Seeley Fire Station and Cooling Center

County Project No. SR49337

ADDENDUM NO. 2

NOVEMBER 29, 2022

| PROJECT TITLE: SEELEY FIRE STATION & COOLING CENTER | SHEET A7.00 |

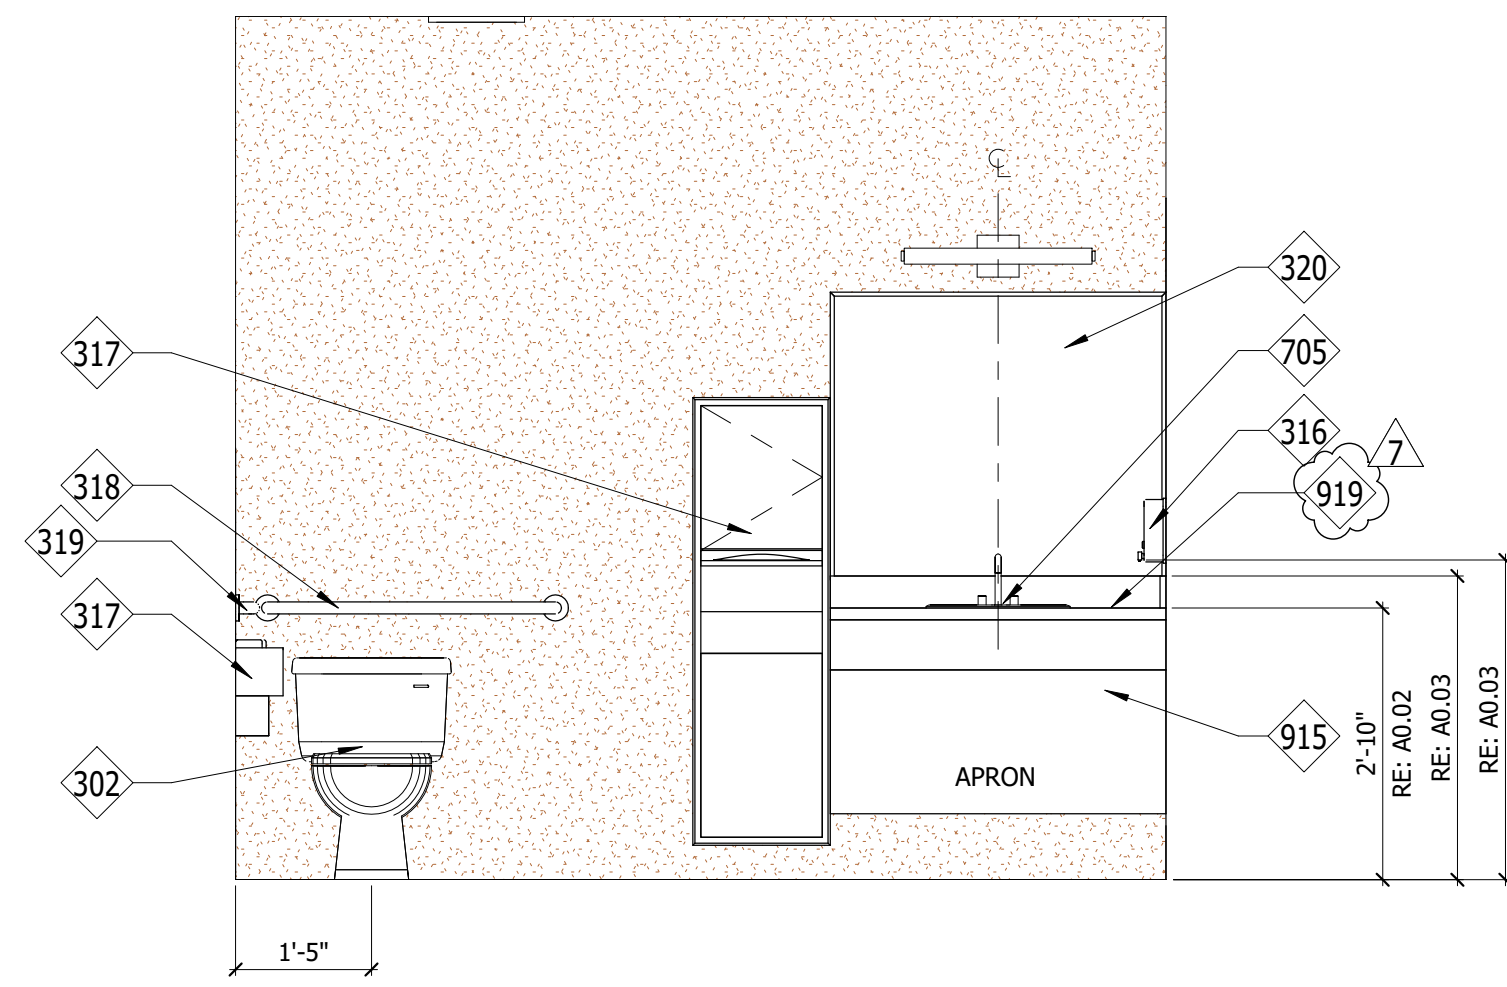
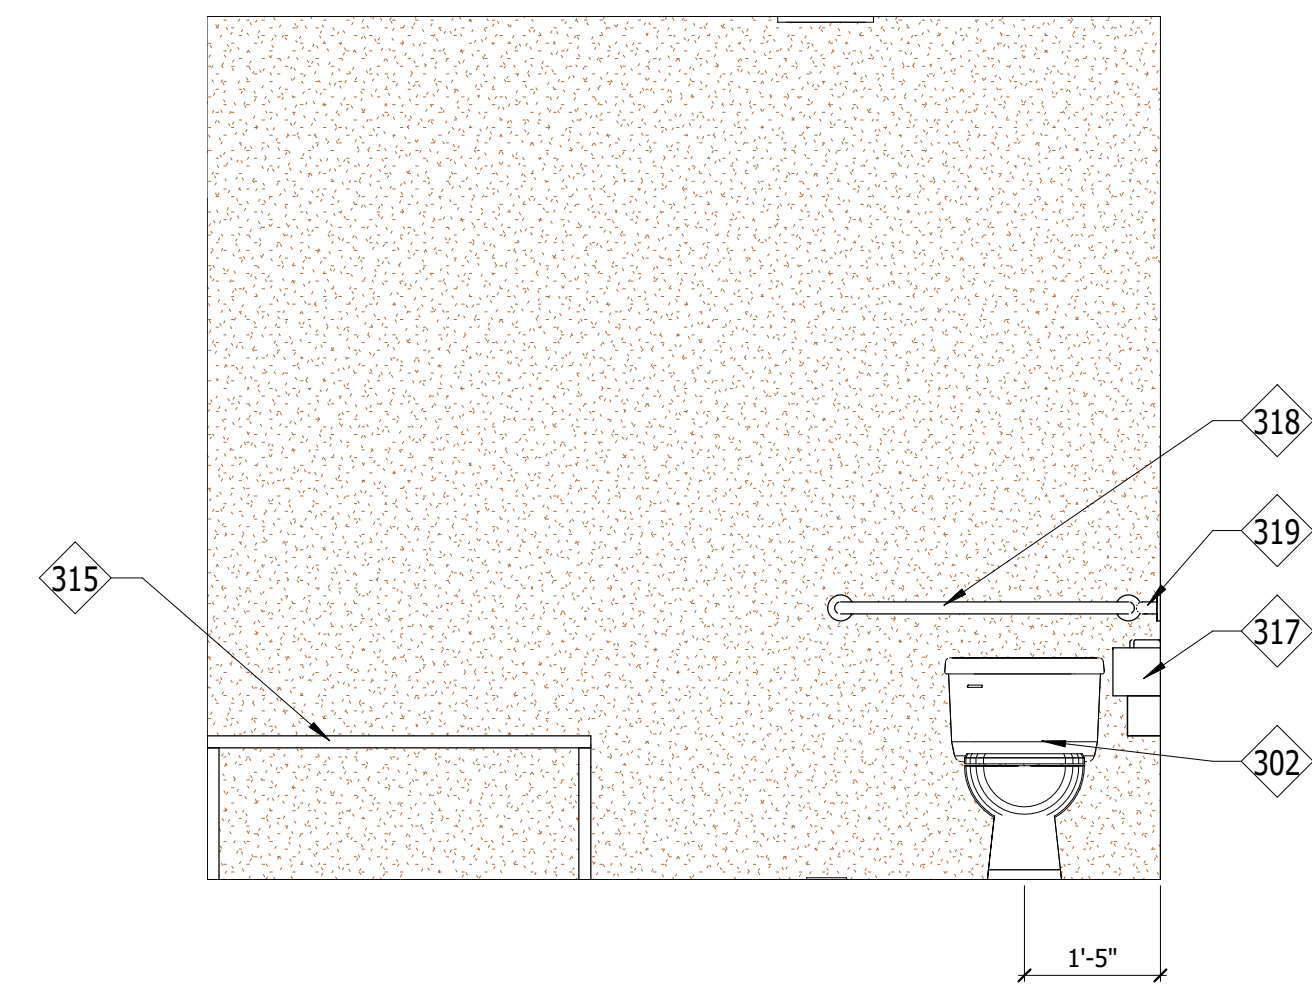
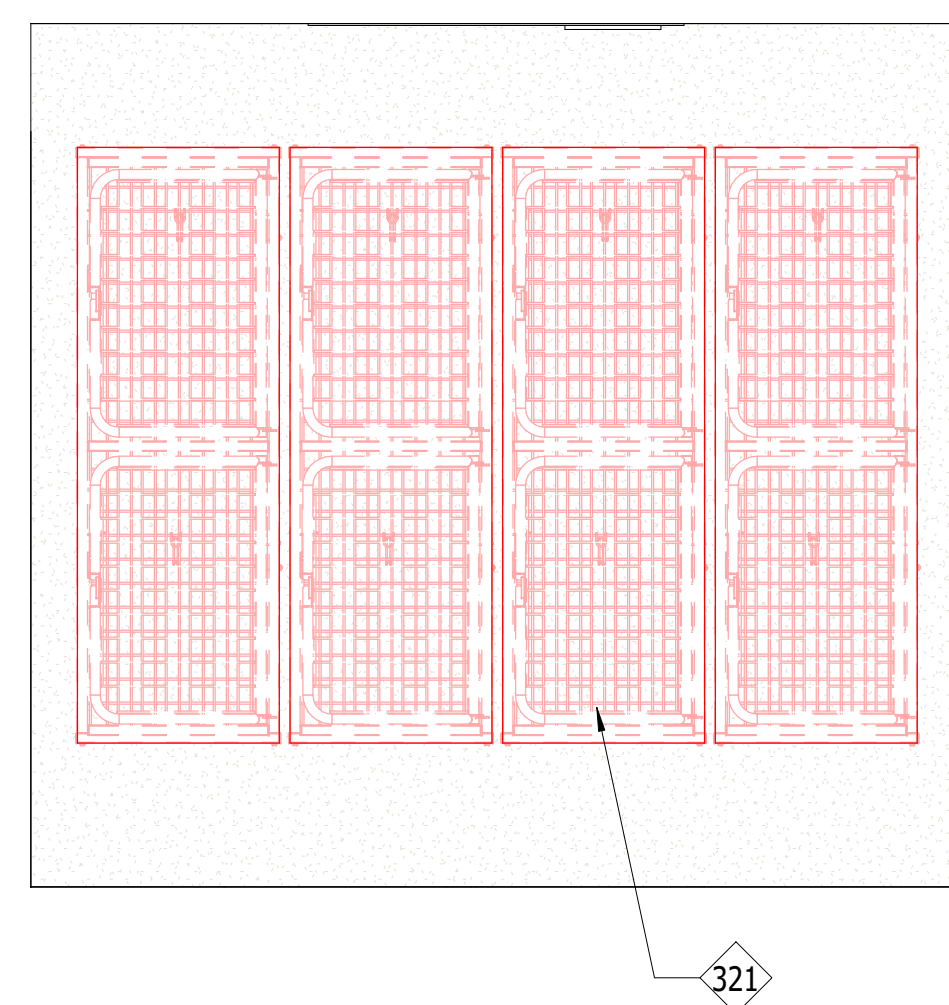
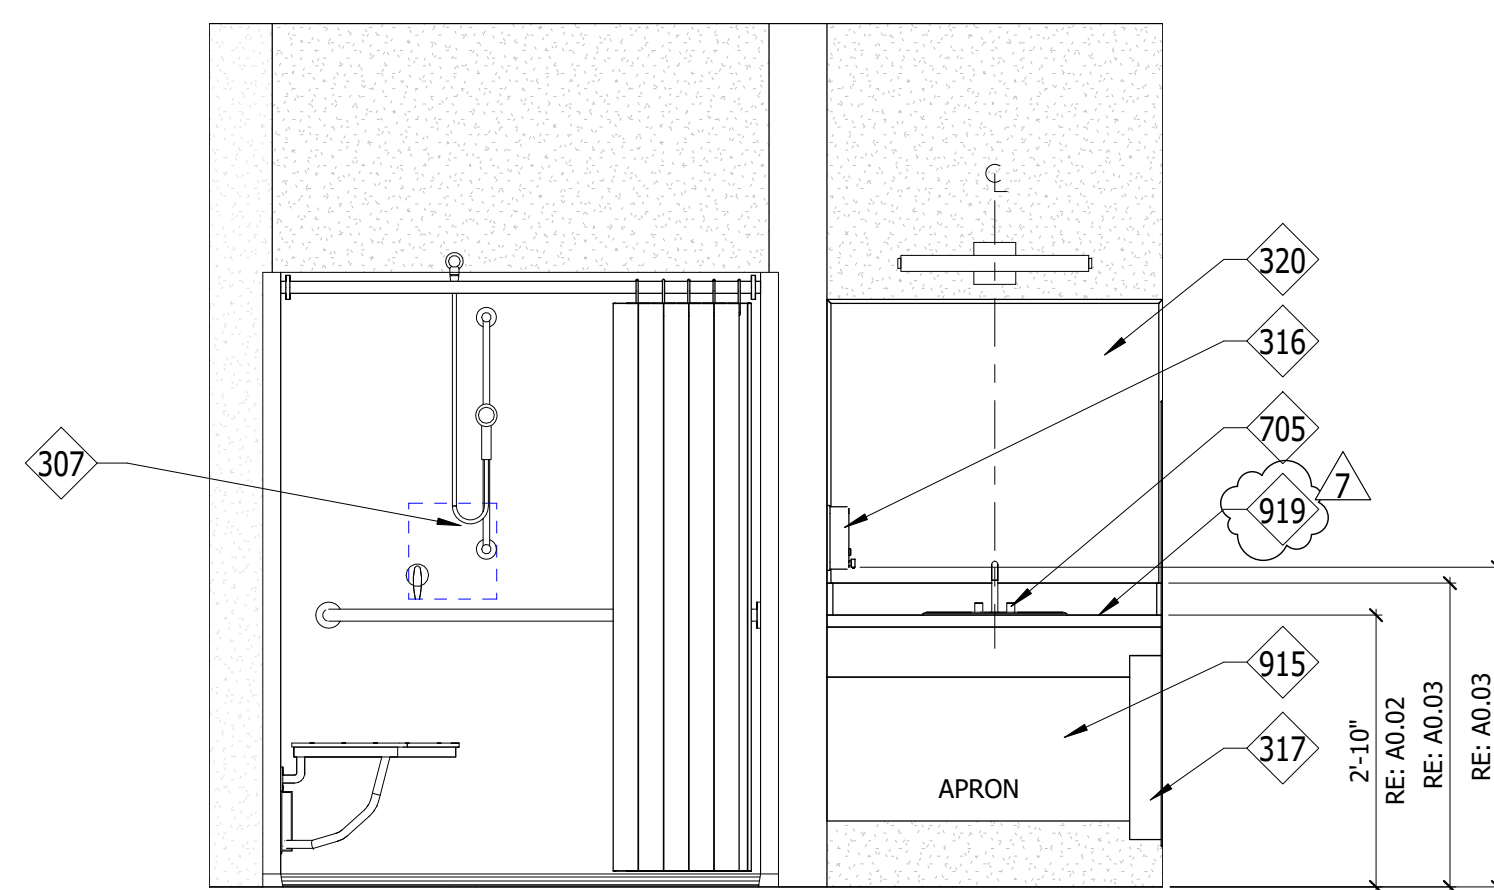
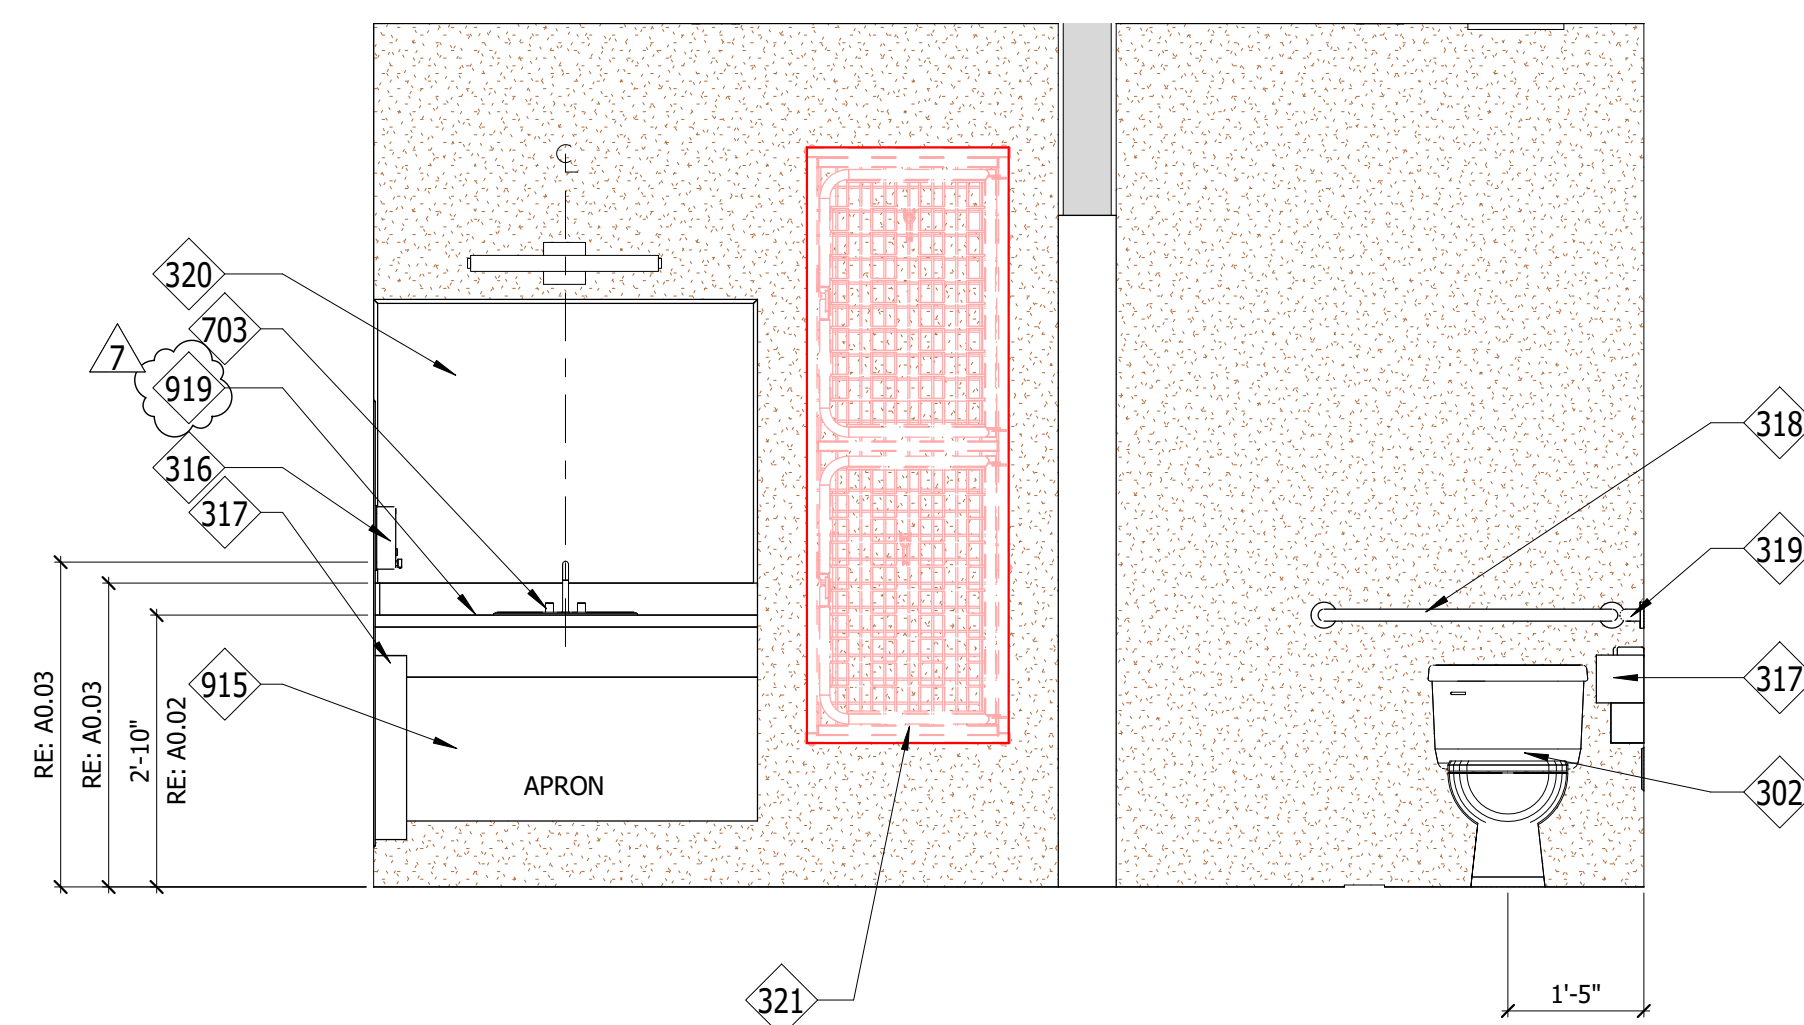
Question 49: **Sheet A3.30 shows PLAM at the restroom countertops and sheet A7.00 shows stainless steel. Which one is it?**

Response: Both are incorrect. Please refer to revised plan sheets A3.30 and A7.00 within Addendum No. 7, in which requires the countertops in the restrooms to be QTZ-1 and countertops in Kitchen to be SS-1. Please refer to finish schedule on plan sheet A9.00 for further details.

PRODUCT CONSTRUCTION EXAMPLE

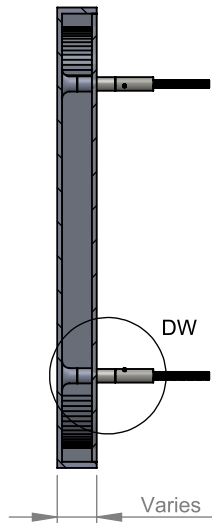
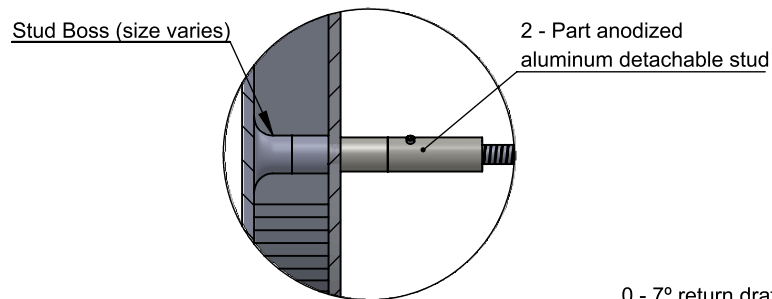
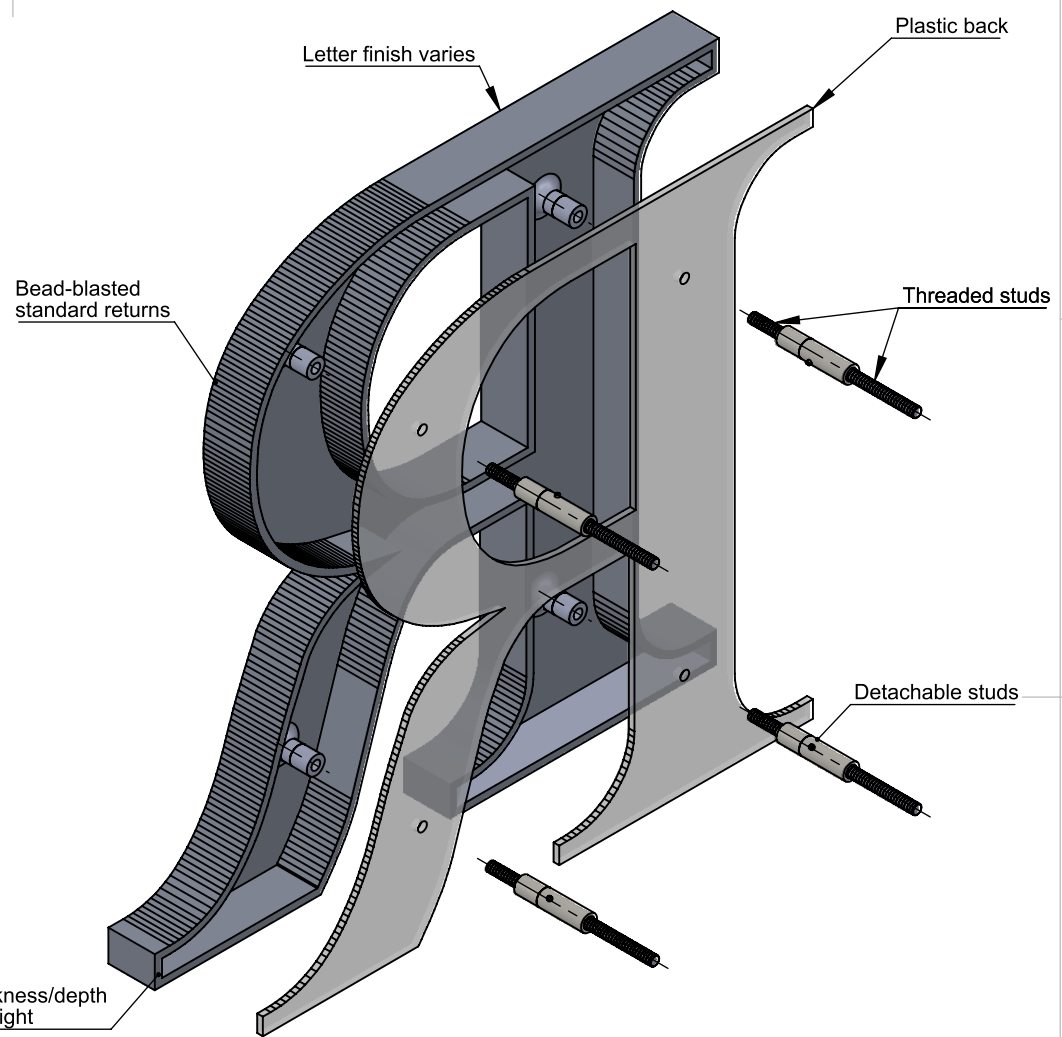
Item 7: Building and Monument Sign Lettering

The lettering for the Monument Sign as illustrated on plan sheet C1.13 and Building Signs as illustrated on plan sheet A5.00 and called out by keynotes 522 & 524 shall be mounted per the attached drawing with concealed electrical circuitry. The Monument Sign Detail on plan sheet C1.13 shall be modified to require 6-inch-high bronze letters with "Warm White" LED lighting. The Building Sign letters shall be 10 inch-high bronze letters with "Warm White" LED lighting.
